B.M.C. 23B.32.040: Findings for Issuance and Denial and Conditions

DAP Draft: 2024 Durant (R-3 downzone)

Construction on two buildings and lots simultaneously is too disruptive for the neighborhood

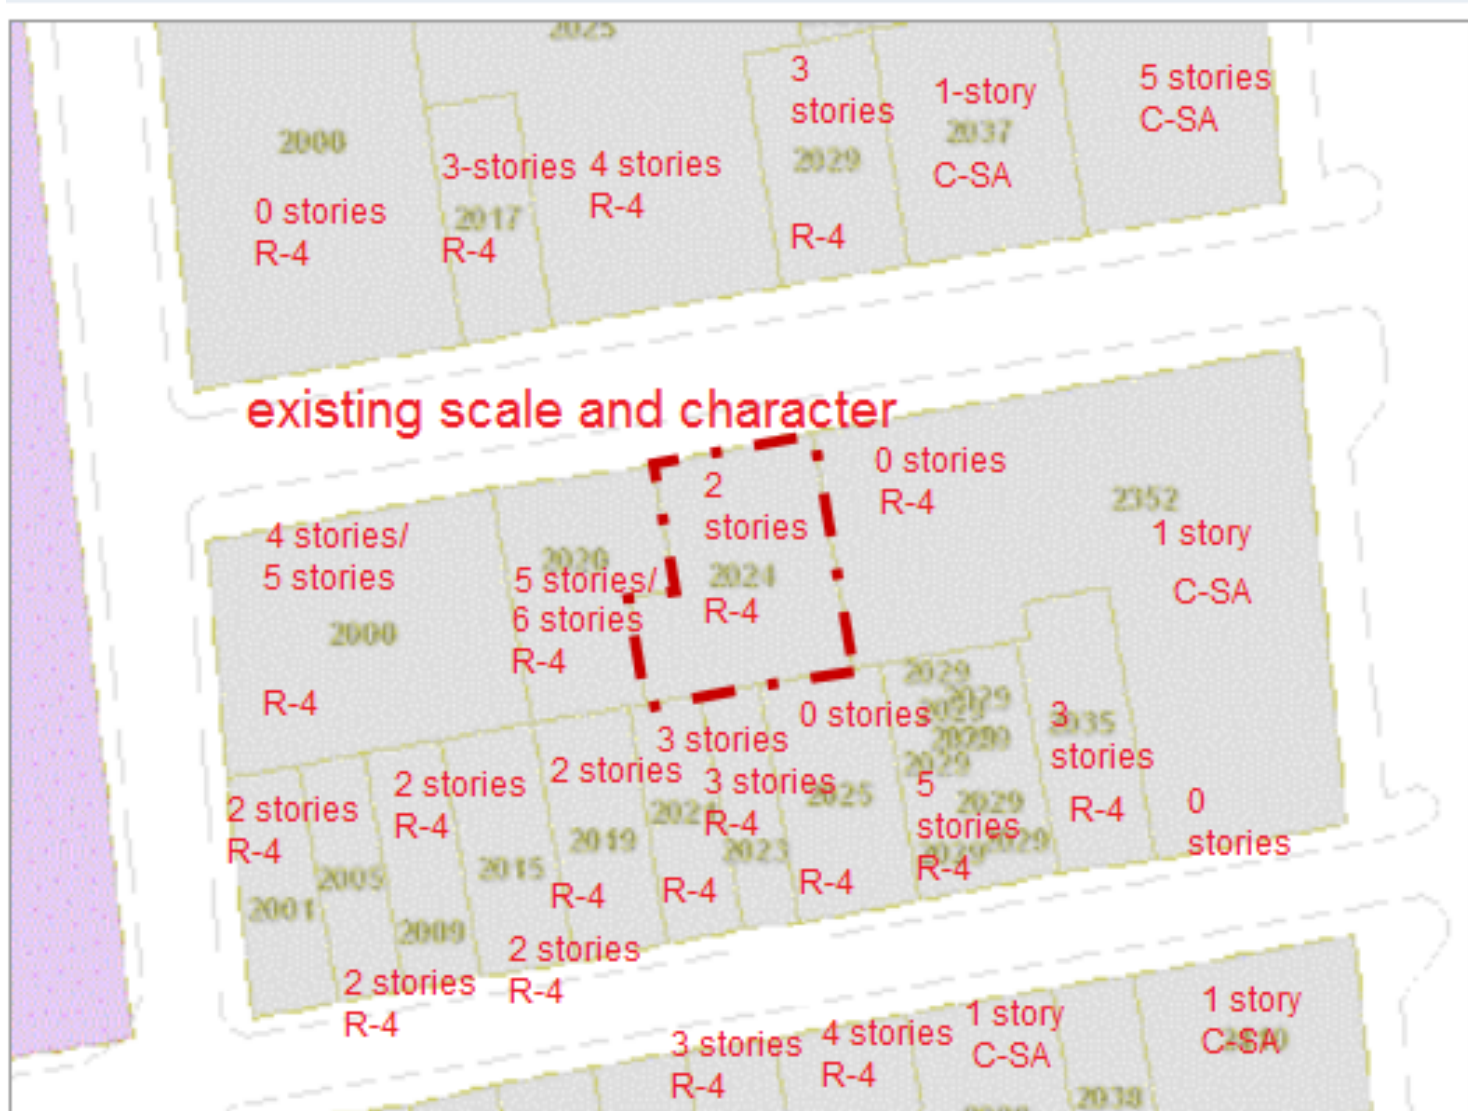
No upzoning for smooth transitions

- Staples has a lease to 2038, the parking lot is zero stories, Staples is one story, a six-to-eight story building at 2024 Durant would create a sharp transition for thirty years
- The “hole” argument about being stuck between taller buildings also applies to properties such as 2020 Durant--if new owners wanted to build a new building it would be limited to three stories, and could be stuck between a six-to-eight story building at 2024 Durant and an existing four-to-five story building at 2000 Durant

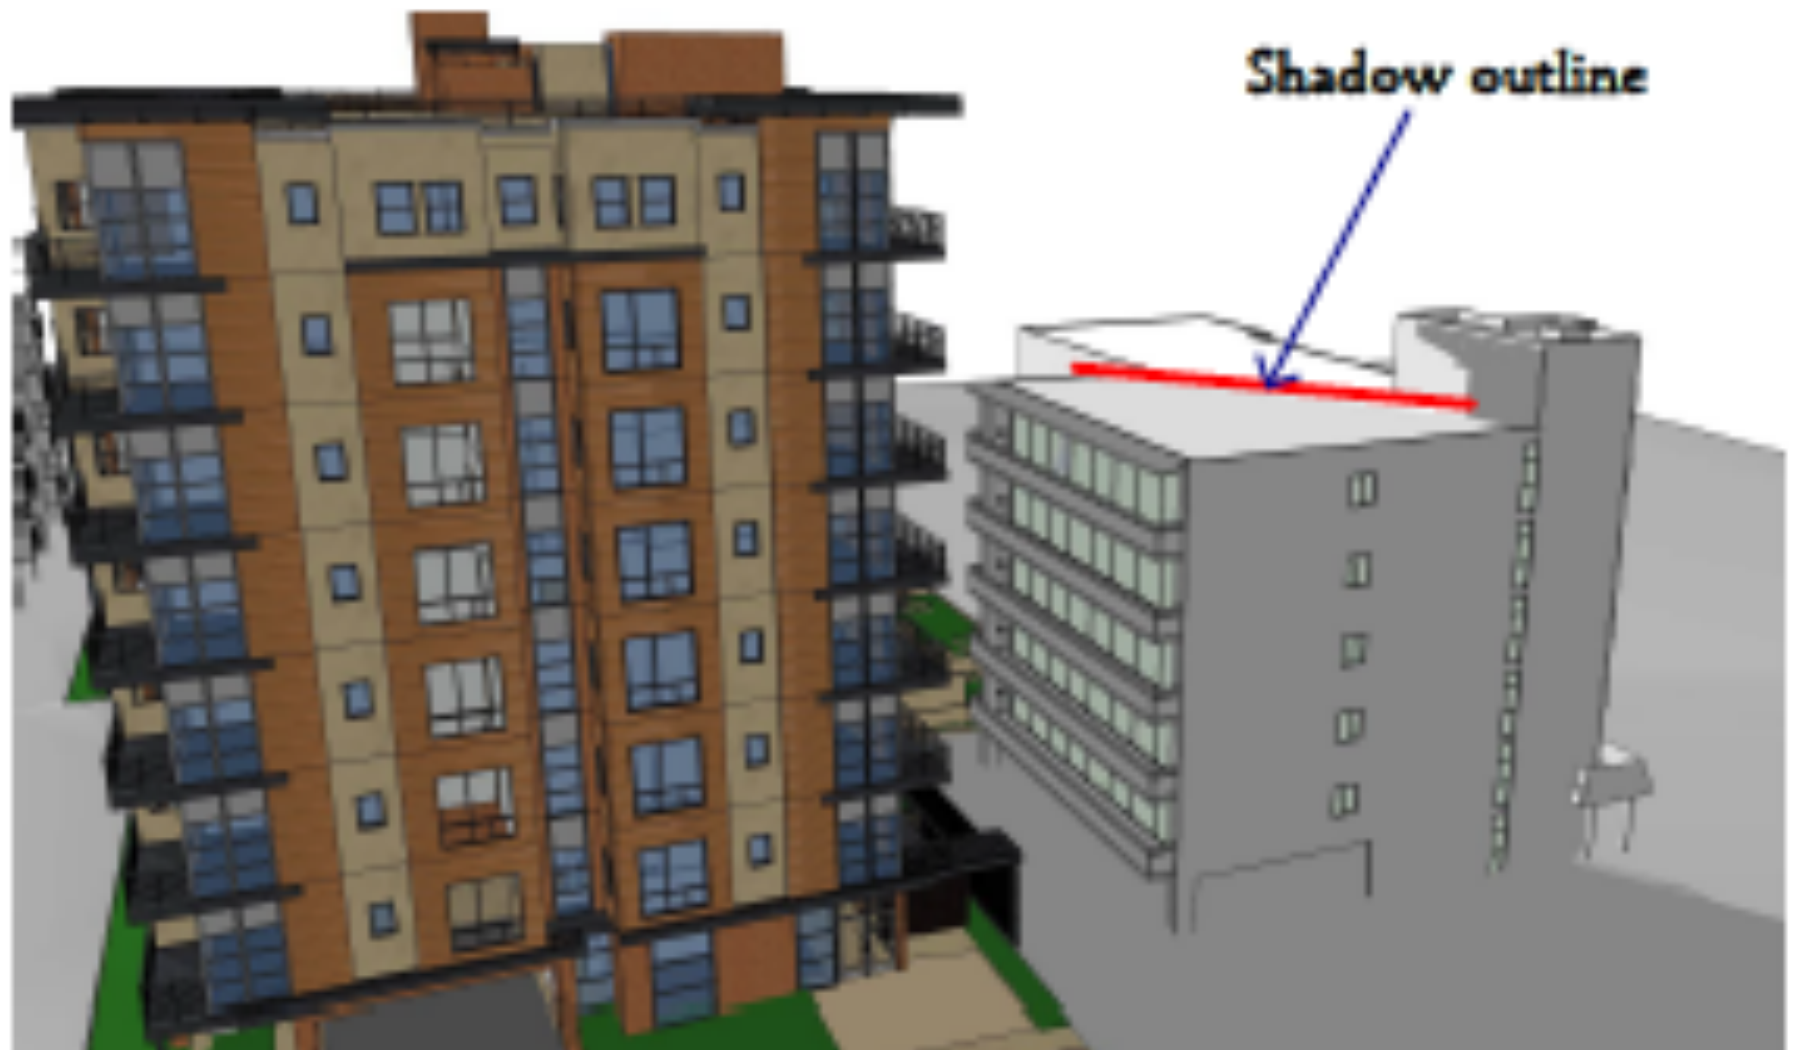
The DRC said 8 stories is inappropriate.

Six stories is also inappropriate.

- “The DRC...felt that eight stories at this location **appears to be in conflict with what was envisioned in the buffer area.**”

- “Recommendations:
8 floor/4 floor massing, is a nice proportion generally, **but not in such a sensitive buffer area.**”

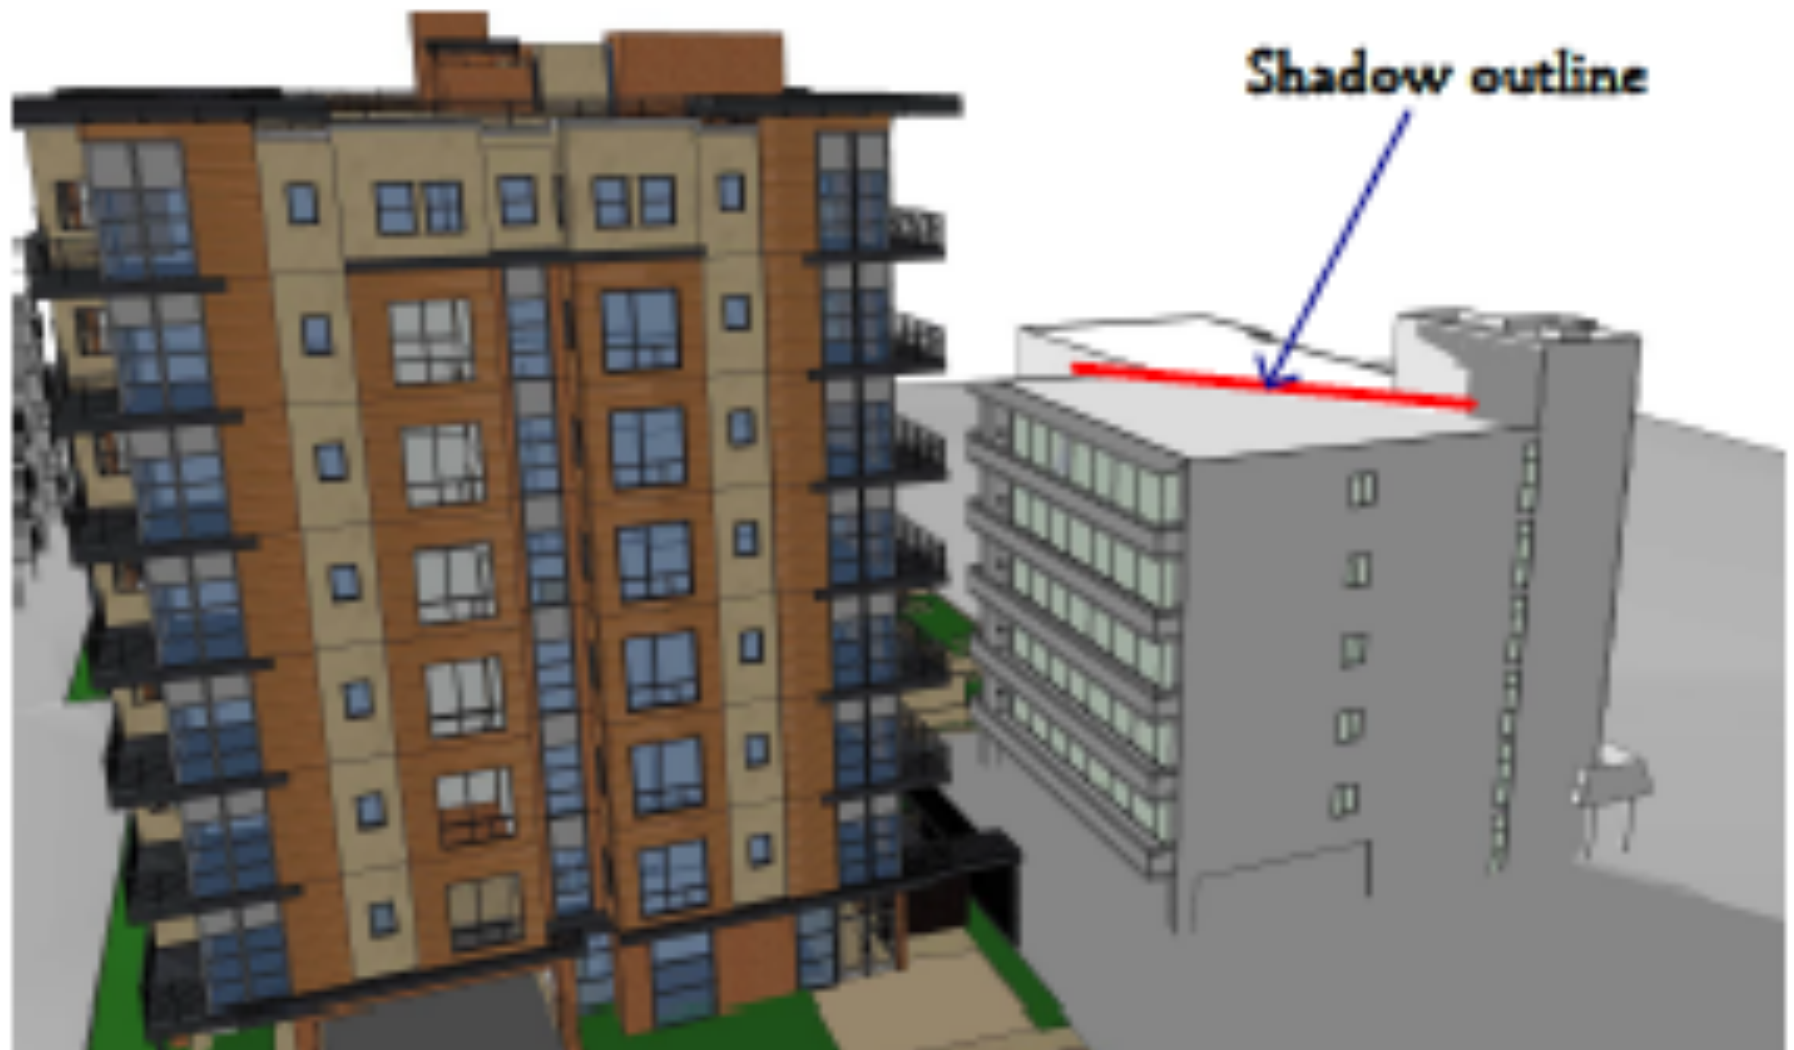
The seniors will lose 80% of the available sunlight

- Sunrise is usually between 5:30AM and 7AM—by 11AM the sun will nearly be overhead, then will pass over the building, so the seniors at most may have 30 minutes to 1 hour of direct sunlight a day
